## OVEN MOUNTAIN PUMPED HYDRO ENERGY STORAGE

# Amendment Report

Oven Mountain Pumped Hydro Storage Pty Ltd

E230869c RP1

Oven Mountain Pumped Hydro Energy Storage Project  
Amendment report  
OMPS Pty Ltd  
Figure 3.14

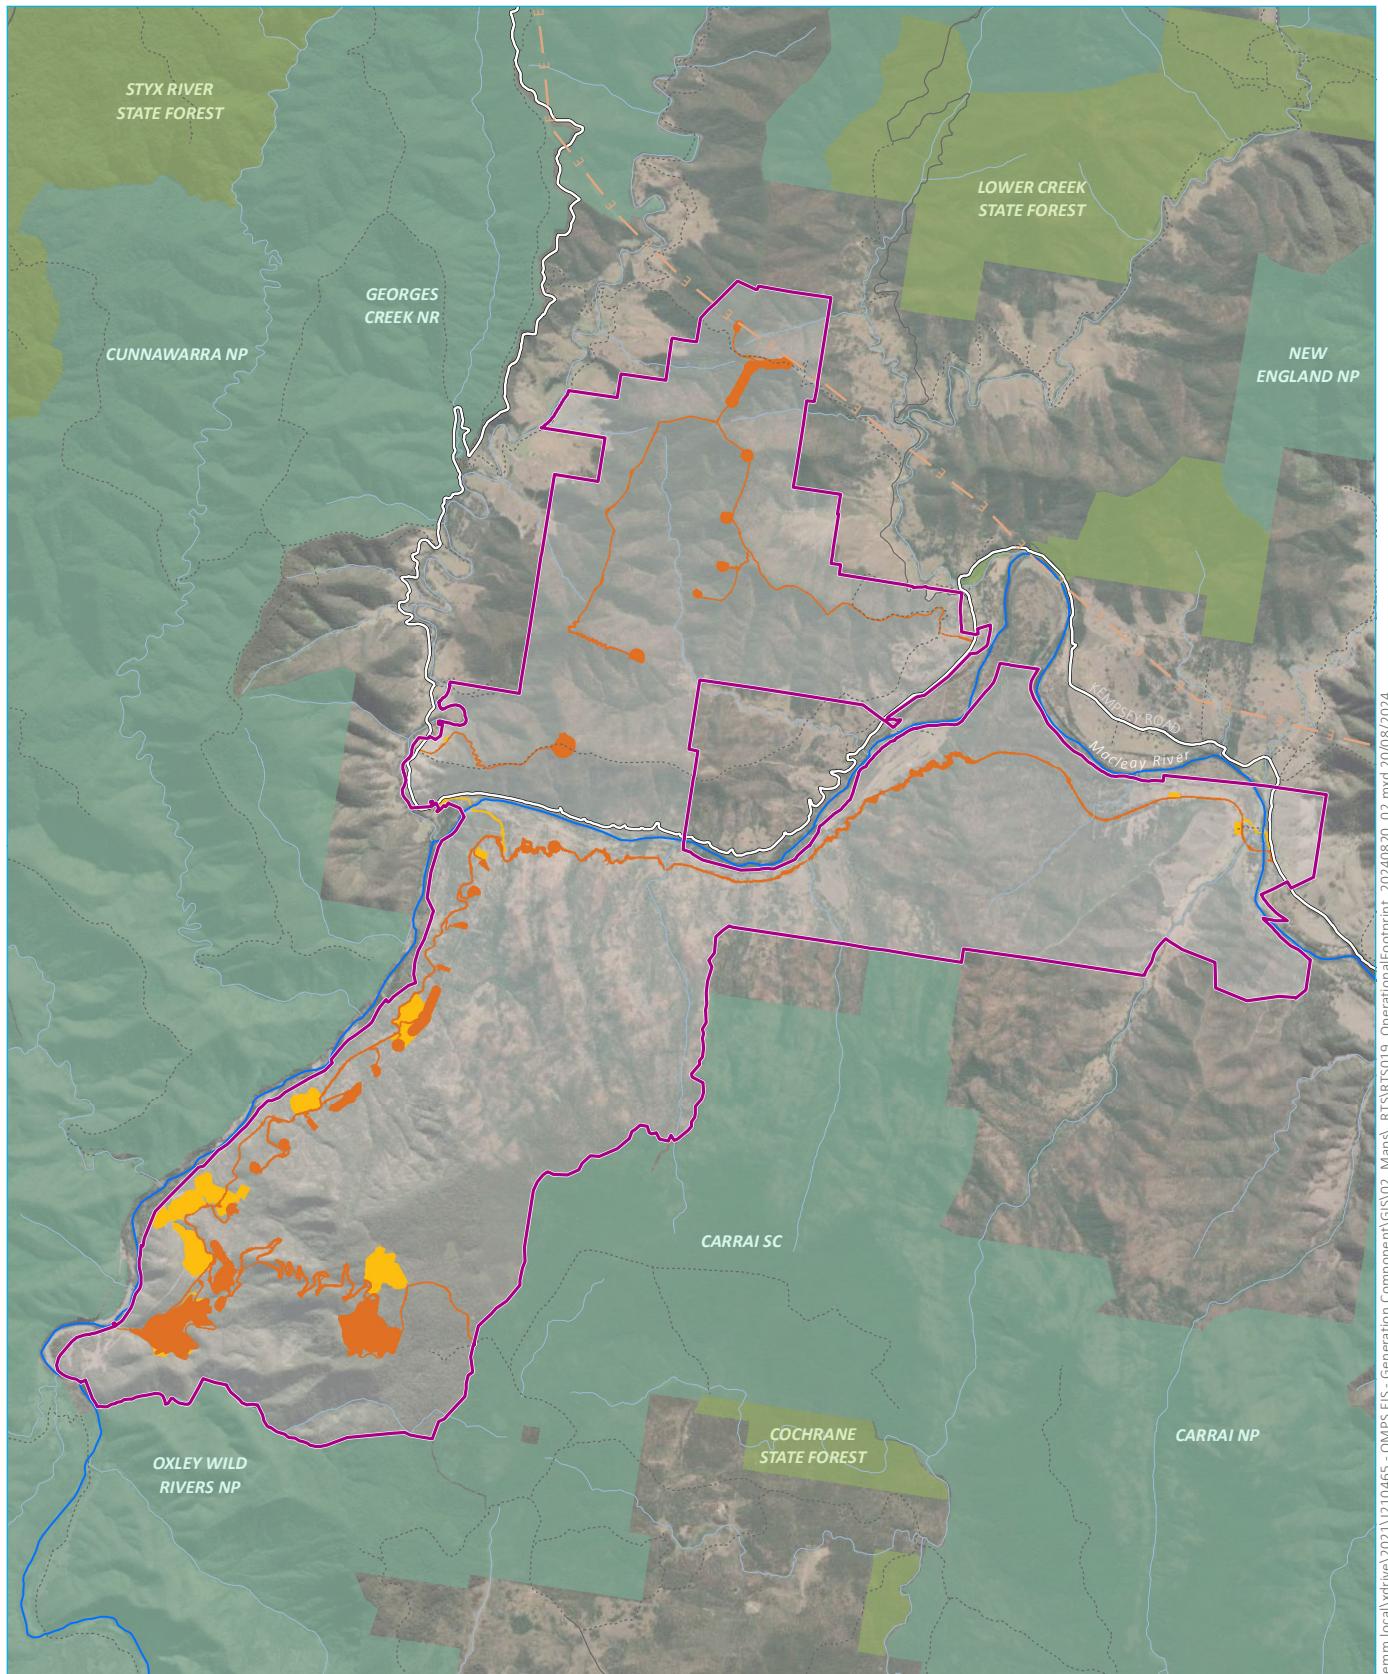
Updates to the operational footprint to accommodate design changes have increased the operation footprint from approximately 270 ha to approximately 280 ha. The amended operational footprint is shown in Figure 3.14.

**Plate 6.1** **Upper PSE comparison**

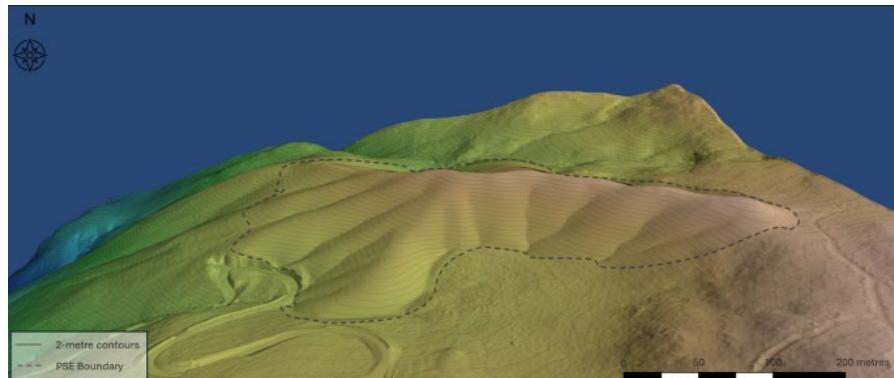
The updated design has a greater footprint but more stable slope design and overall, blends in more seamlessly with the surrounding landscape.
